City of Albuquerque

Re: Bluewater/94th Storm Drain Drainage Report
Engineer Stamp date 12-22-01 (K9/D22)

DRAINAGE ANALYSIS

Bluewater Road near 90th Street

ENGINEER'S SEAL	WEST RIDGE MOBILE HOME PARK	DRAWN BY: WCHJ
	FUTURE DEVELOPED BASINS / DRAINAGE MANAGEMENT PLAN	DATE: 1-24-02
	TERRA WEST, LLC 8509 JEFFERSON NE ALBUQUERQUE, NEW MEXICO 87113 (505)858-3100	2119BASIN.DWG
	RONALD R. BOHANNAN P.E. #7868	SHEET # 21019

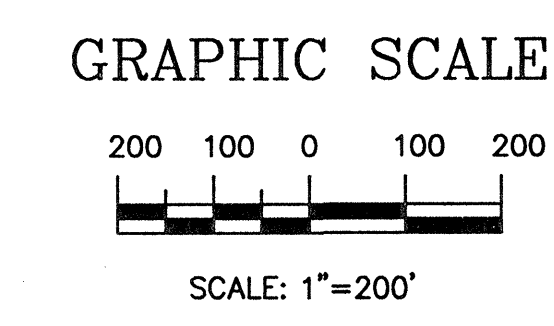
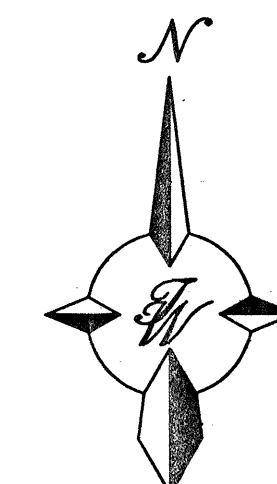
- On the developed basin map, please add all pipe sizes in Bluewater, 90th and Volcano, and denote if they are existing, proposed or future.
- Also, please add runoff (Q's) from Avalon 2, WRMH2, WRMH and the basin west of WRMH to your basin map.
